MR#2023013 – VEIRS MILL ROAD BUS RAPID TRANSIT AND BICYCLE & PEDESTRIAN PRIORITY AREA (BIPPA) PROJECT MANDATORY REFERRAL

NO. MR2023013

COMPLETED: 04-06-23

April 13, 2023

Figure 11: Randolph Road WB BRT Station

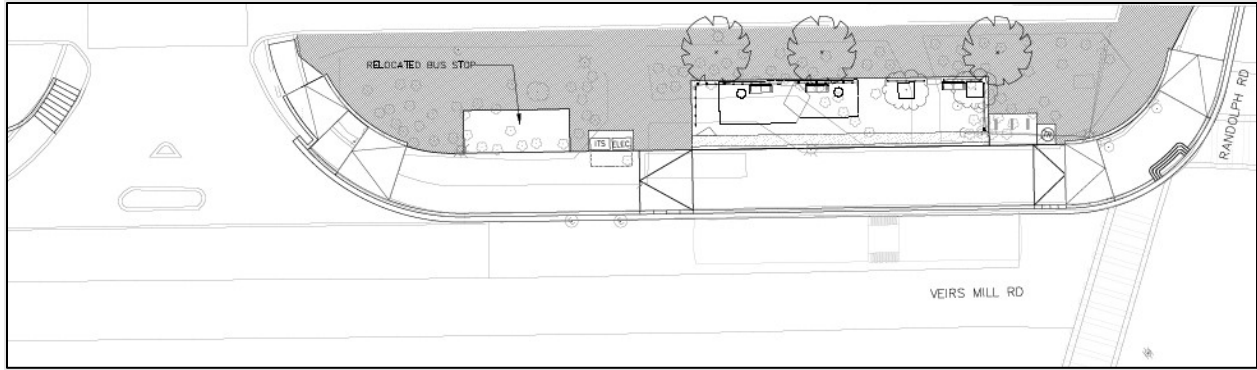
- a. Westbound Randolph Road BRT Station. This is a busy bus station for the BRT network and forcing through pedestrians and bicycles to cross directly in front of this BRT stop is a safety concern.

One primary comment that we want to draw attention to is the siting of the Randolph Road westbound BRT Station. Figure 11 displays the plan view of this station. It shows that the sidepath will be located between the station and the road and therefore will also serve as a waiting location for passengers. Given the high ridership at this location, Planning staff is concerned about mixing bus passengers waiting at this station with the sidepath between the station and the curb. Efforts should be made to explore ways to modify this design to relocate the sidepath behind the station platform.
